Subject: Ogden Valley Ground Water Study

Policy Comments on UGS Ogden Valley Hydrogeology Report (Jordan, 2019)

E. Miranda Menzies, Eden Utah, Jan 2021

Comments on UGS Ogden Valley Hydrogeology Report

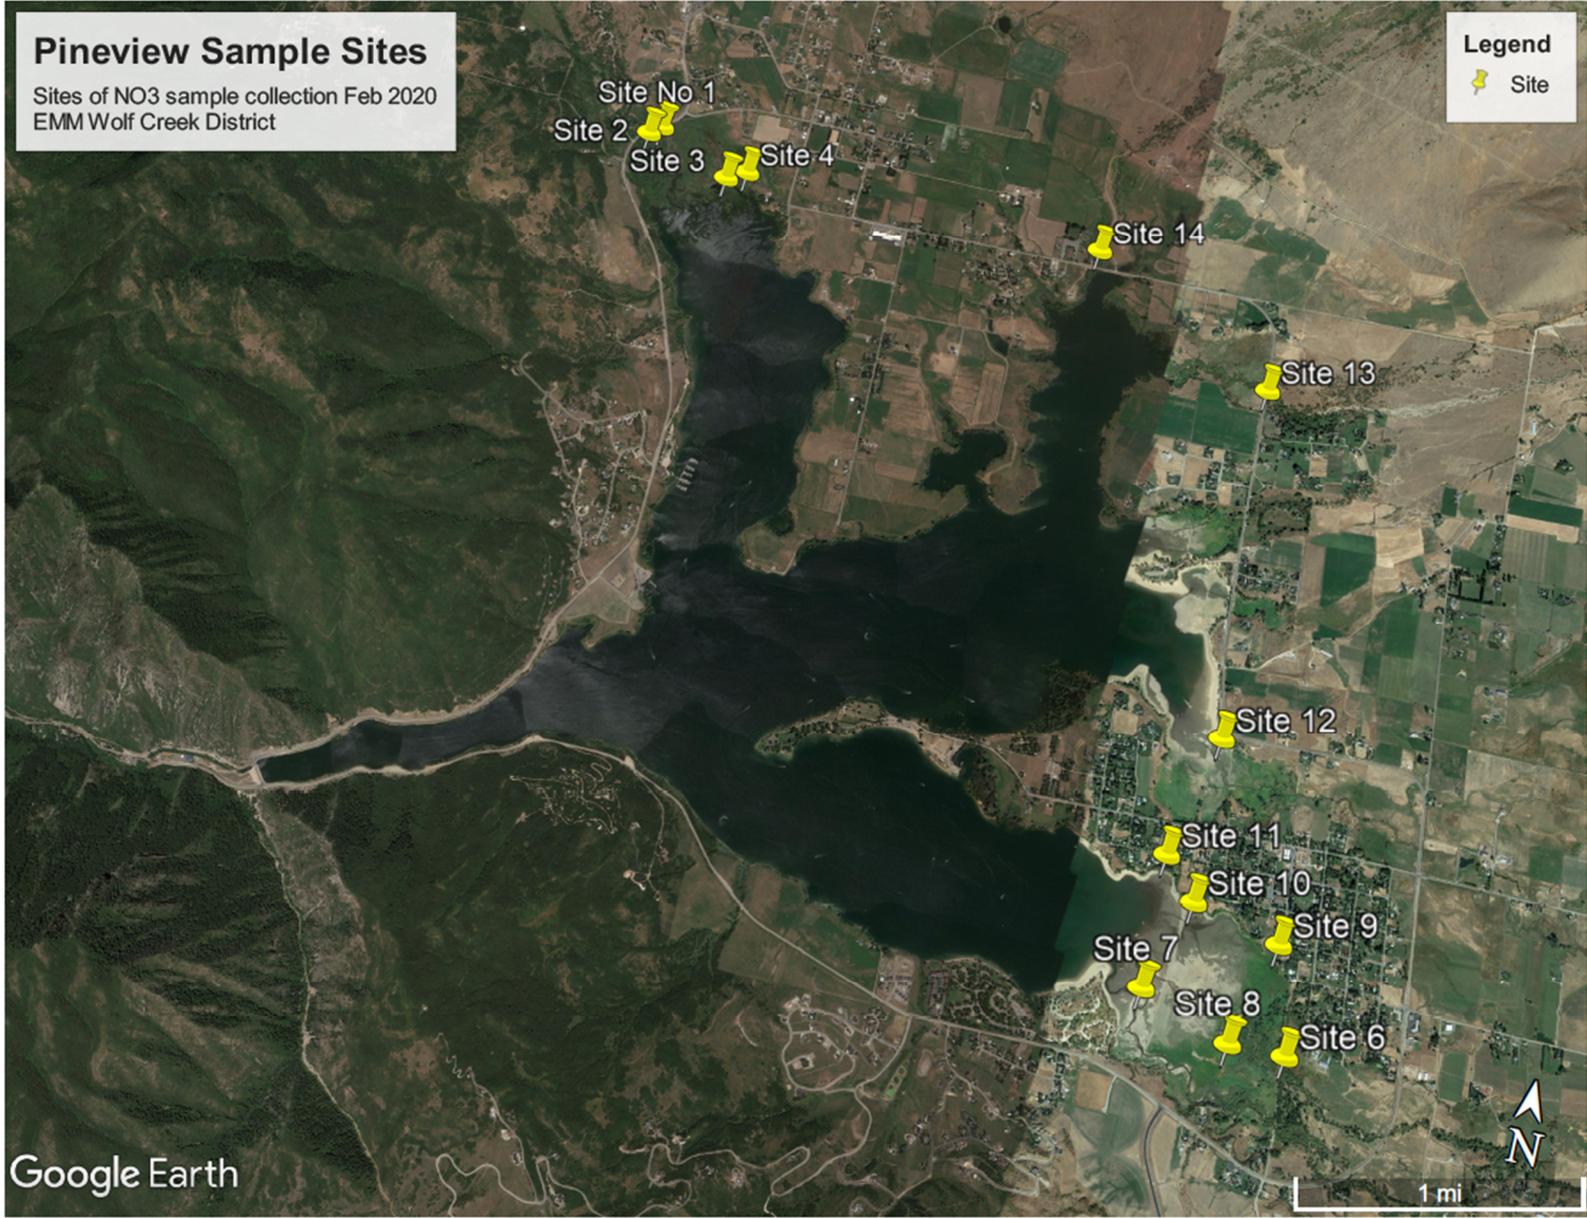
Sampling of discharging groundwater that I performed in 2020 (February and September) along the margins of Pineview Reservoir confirmed the typical groundwater values reported in the UGS report. (Full results have been provided to UGS and Forest Service, landowner). The shallow unconfined aquifer discharges in multiple locations around the North Arm, along the west side of the Stringtown Road peninsular, on both sides of the Huntsville peninsular, and some other channel discharges at Gertsen Bay and Middle Fork. This appears to be because the confining unit approaches the ground surface in these areas, encouraging discharge.

Sampling of all major discharges around the lake, in particular springs differentiated by field temperature, resulted in two datasets with a geometric mean concentration of nitrate in ground water samples of 0.43 mg/l and 0.48 mg/l (arithmetic mean 0.58 mg/l and 0.72 mg/l). Several locations that were downgradient of areas of homes with septic systems contained nitrate above 1 mg/l.

- This completely independent approach confirmed the UGS results for the typical concentrations in the shallow groundwater. These concentrations are well below the primary drinking water standard of 10 mg/l.

- The nitrate concentration of the North Arm East Spring sample was 1.24 mg/l in February 2020 and 0.85 mg/l in September 2020. This spring was nearest to the monitoring well No 1 sampled by Reuben and appears generally downgradient of it. This suggests that the groundwater Reuben (2013) sampled, which was reported to have a mean of 14.1 mg/l and range of 2.5 to 47 mg/L, is either diluted by other groundwater flows prior to discharge, or discharges elsewhere.

- The Pineview reservoir concentrations seem to be close to “background” concentrations (0.1 to 0.2 mg/l). Ogden Valley/Causey Canal and Middle Fork water were also at background levels.

- Comparing the averages to the concentration reported in the UGS Report from the Ogden City well in the confined aquifer (1.43 mg/l) suggests there is another factor(s) involved with this well.

Figure A

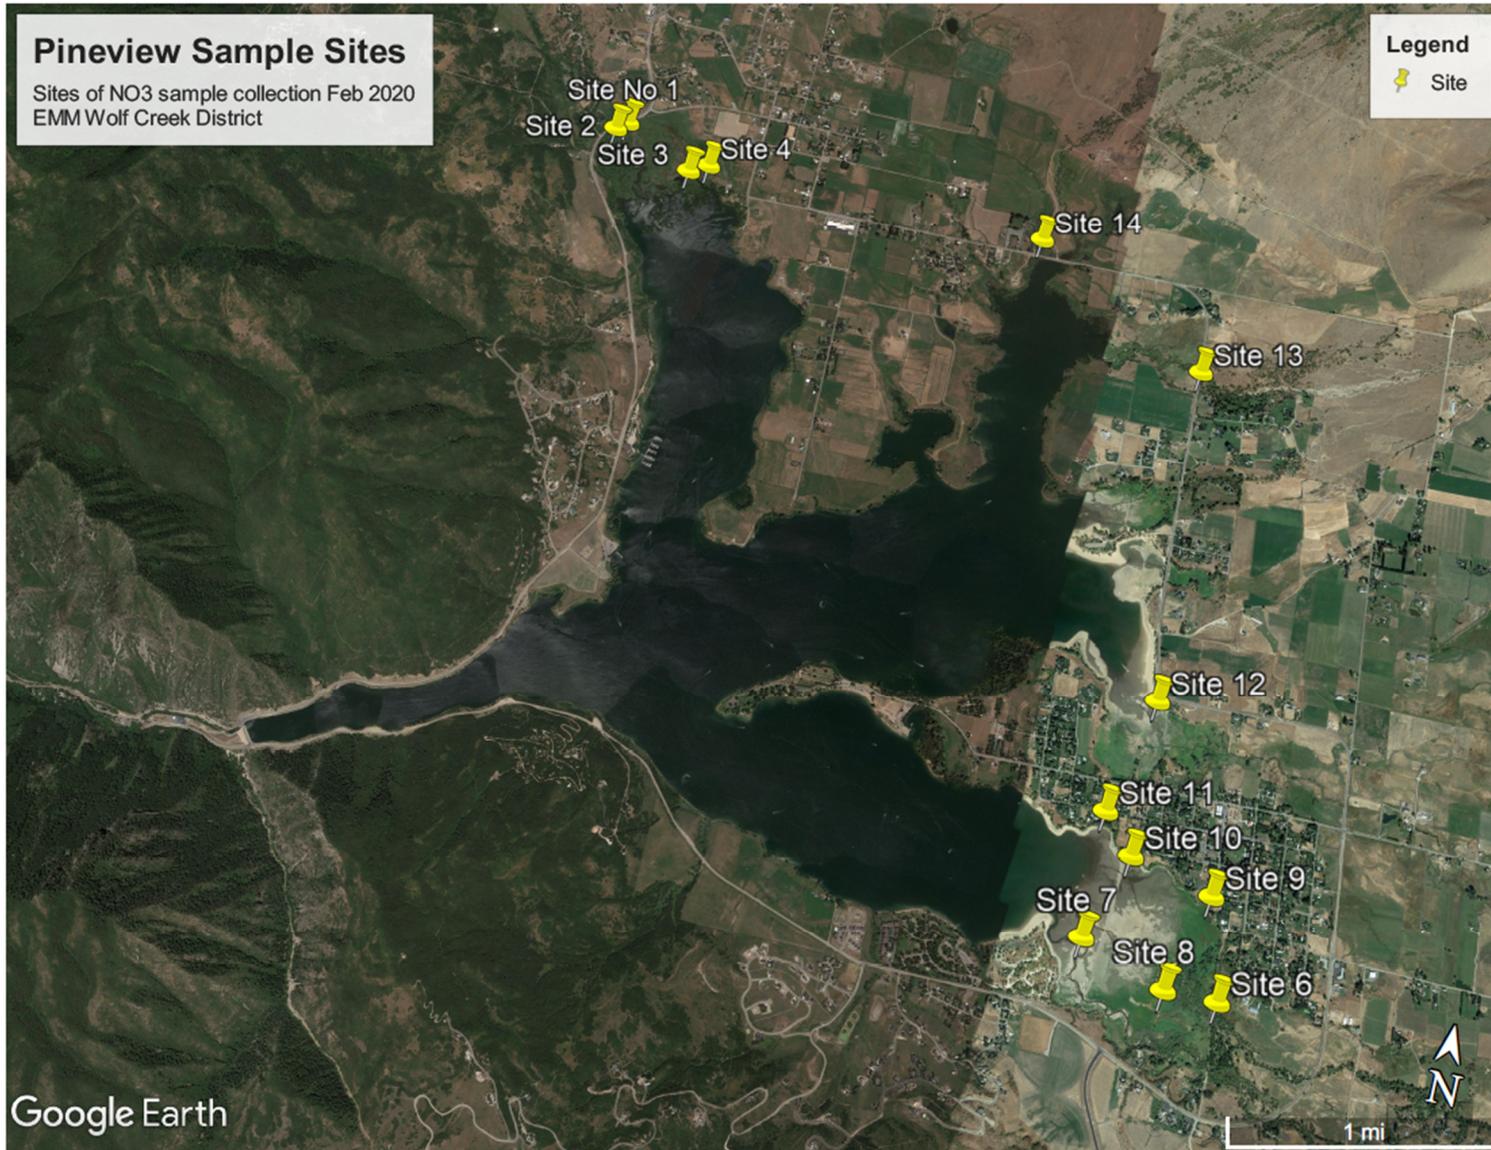
UGS report states that the geometric mean nitrate concentration from UGS samples was 0.45 mg/l, and the arithmetic mean was 1.04 mg/L. The UGS report and these comments assume that nitrate in groundwater does not degrade, and is conservative. Sources include septic systems, fertilizers on crops and lawns and livestock. As described below, these overall results were confirmed by sampling discharging groundwater (Table 1 and Figure A)

The samples were collected using a rinsed bucket, stored under standard Chain of Custody in a cooler with ice/refrigeration, and analyzed at the Weber Basin Conservancy District certified laboratory for nitrate and in some cases orthophosphate. Sample field temperature was used as an approximate guide to the source of the water, and flow rate was estimated based upon channel dimensions and flow velocity. The results are shown on Table 1. Sample locations from February 2020 are shown on Figure A.

- The geometric mean of ground water samples in both datasets (0.43 mg/l and 0.48 mg/l) are similar to the geometric mean in the UGS report (UGS report geometric mean of 0.45 mg/l). Arithmetic mean for all samples which include 'surface water' was slightly lower but similar in magnitude (0.58 mg/l and 0.72 mg/l compared with 1.04 mg/l in the UGS report). Much of this surface water likely is groundwater discharge given the sampling dates.

- In other words, a completely independent approach confirmed the UGS results for the typical concentrations in the shallow groundwater. It is worth pointing out again, that the concentrations are well below the primary drinking water standard of 10 mg/l.

- The nitrate concentration of the North Arm East Spring sample was 1.24 mg/l in February 2020 and 0.85 mg/l in September 2020. This spring was nearest to the monitoring well No 1 sampled by Reuben and generally downgradient of it. This suggests that the groundwater Reuben (2013) sampled, which was reported to have a mean of 14.1 mg/l and range of 2.5 to 47 mg/L, is either diluted by other groundwater flows prior to discharge, or discharges elsewhere.
